## CARDIAC CATHETERIZATION LABORATORY

## Riverside University Health System Medical Center
## 26520 Cactus Ave, Moreno Valley, CA 92555

(PROJECT NO. MC08430011869, HCAI NO. S231455-33-00)

F ROUND 1 RFI RESPONSE

SHEET NUMBER
AE517

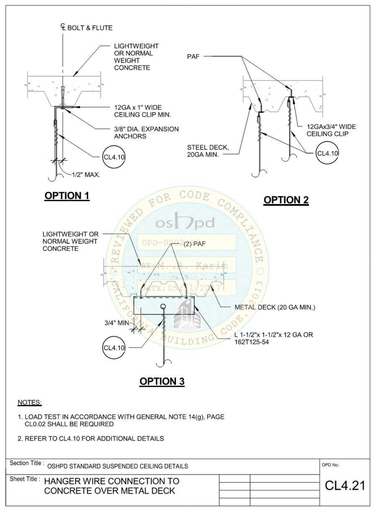
| B028 | 2/24/2026 | Brady West Inc | #027 | Dets. A3, A5 & D5/AE515 & D1, D3 & D6/AE516 refer to Brace per schedule on ST6.01, however, this detail is not found. Please provide this detail | LAD | Detail ST6.01 is added to sheet AE517. |

| Sheet Title : JOISTED GYP BOARD CEILING BLOCKING DETAIL | | CJ2.10 |

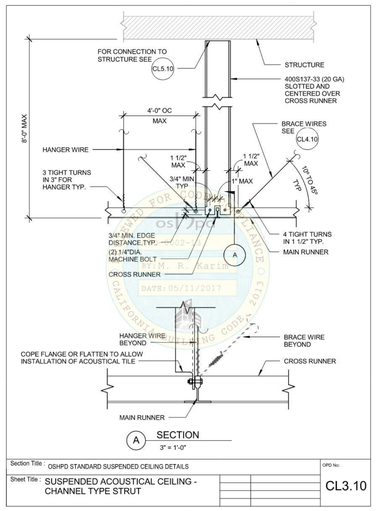
| B026 | 2/24/2026 | Brady West Inc | #025 | Det. A1/AE121 refers to detail CJ2.10 which is not shown. Please provide this detail, | LAD | No reference on sheet AE121 for CJ2.10. Perhaps this is a reference to CJ2.10 the OPD sheets?<br><br>Detail CJ2.10 is added to sheet A519.A. |

**Sheet AE552 (New Sheet)**

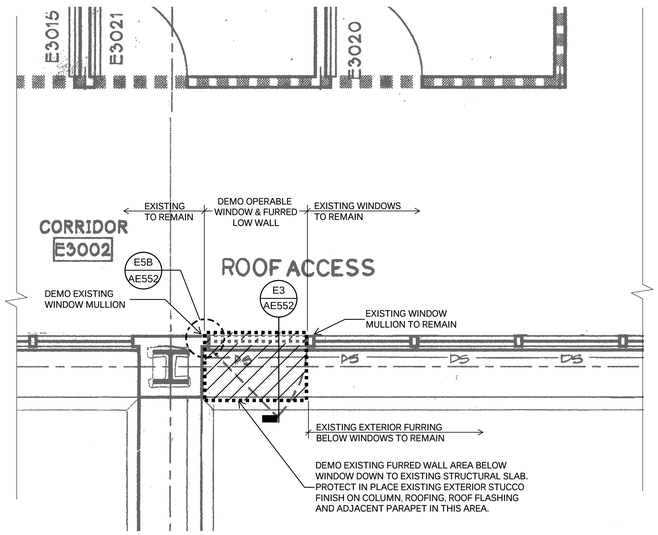
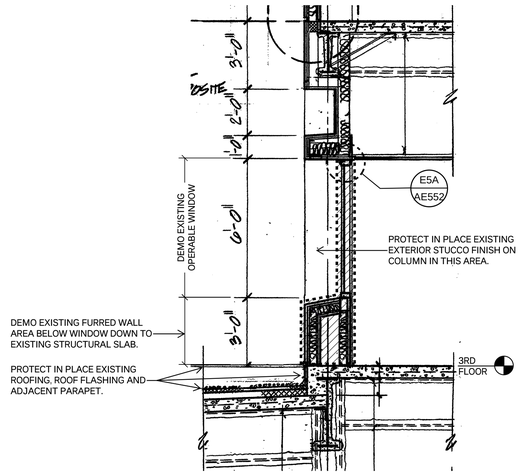
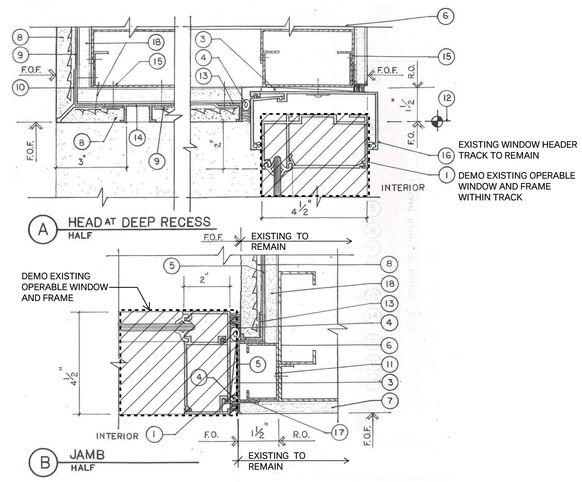
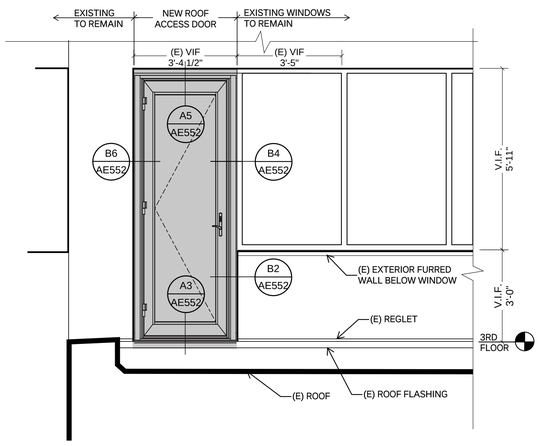
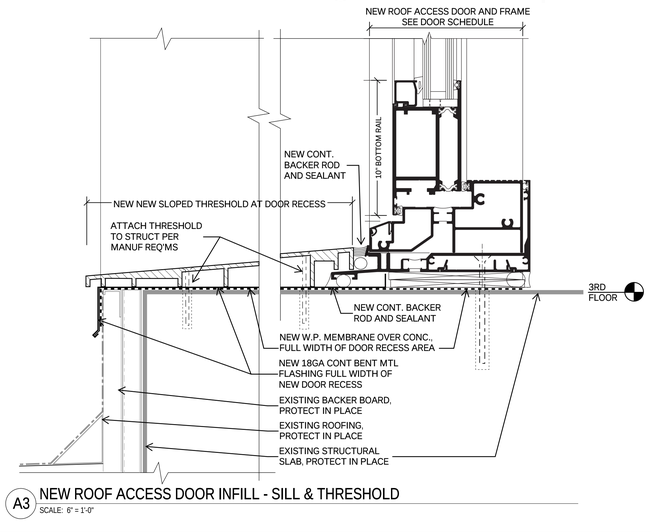
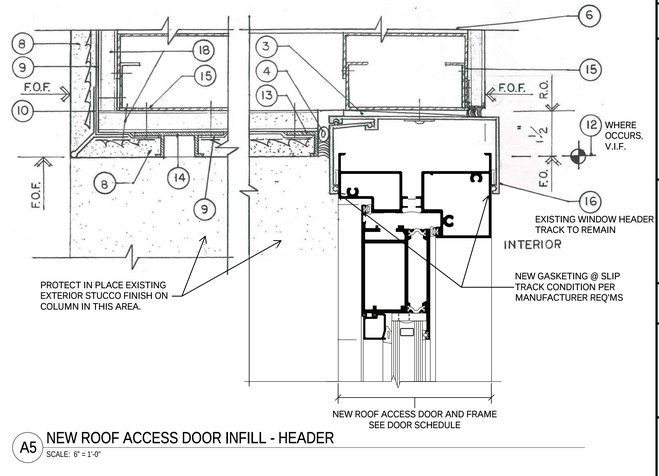
1. Located new 3rd floor roof maintenance access door on D1/AE112 Partial Roof Plan. Added detail references for demo and remodel scope on new sheet AE552.

2. New demo plans and details describing the demo of an existing roof access hatch in the existing exterior storefront window and a portion of the exterior furred wall below the window.
3. New remodel plans and details describing the installation of a new roof access doorway within a single window bay of the existing exterior window system.
